Access Compliance Report

Public Rights-of-Way

(Curb Ramps)

Intersection ID: 5497	Main Street: GRAYS_CREEK_LN	Cross Street: SOUTH_FORD_RD	Location: NW
ADA ID: D6BEC8E3D2C9	Ramp Type: Perp	Initial Pass/Fail: Fail	Overall Compliance: No
Severity Score: 37.5			
Codes/Mitigation Info/Possible Solution		Field Measurements/Component Compliance

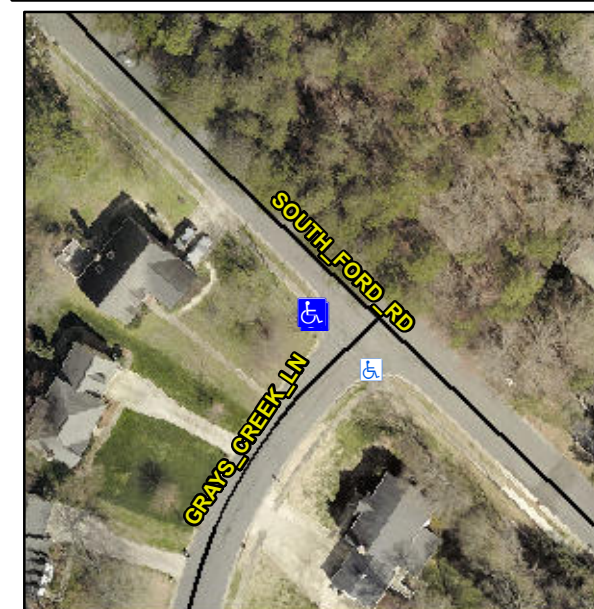
Not Found, R304.2.2, R304.5.3

Compliance	Description	Data	Compliance	Description	Data
N/A	Ramp Length (in)	85.0	No	Ramp Slope (%)	10.1
Yes	Ramp Width (in)	48.0	No	Ramp XSlope (%)	10.0
N/A	Flare Type LT	N/A	N/A	Flare Type RT	N/A
N/A	Flare Slope LT (%)	N/A	N/A	Flare Slope RT (%)	N/A
N/A	Flare Traversable LT?	N/A	N/A	Flare Traversable RT?	N/A
N/A	Landing Length (in)	N/A	N/A	DWS Provided?	N/A
N/A	Landing Width (in)	N/A	N/A	DWS Contrast?	N/A
N/A	Landing Slope (%)	N/A	N/A	DWS Length (in)	N/A
N/A	Landing X Slope (%)	N/A	N/A	DWS Full Width?	N/A
N/A	Landing Curb? (Y/N)	N/A	N/A	DWS Offset (in)	N/A
N/A	Shared Landing?	N/A			
N/A	Gutter Ponding?	N/A	N/A	Gutter Slope (%)	N/A
N/A	Gutter Lip Ht (in)	N/A	N/A	Gutter X Slope (%)	N/A
N/A	Painted X Walk1?	No	N/A	Painted X Walk2?	N/A
	X Walk 1 Direction	To SE		X Walk 2 Direction	N/A
N/A	X Walk 1 Width (in)	N/A	N/A	X Walk 2 Width (in)	N/A
	X Walk 1 Slope (%)	1.5		X Walk 2 Slope (%)	N/A
	X Walk 1 X Slope (%)	4.9		X Walk 2 X Slope (%)	N/A

Remove & Replace Entire Ramp.
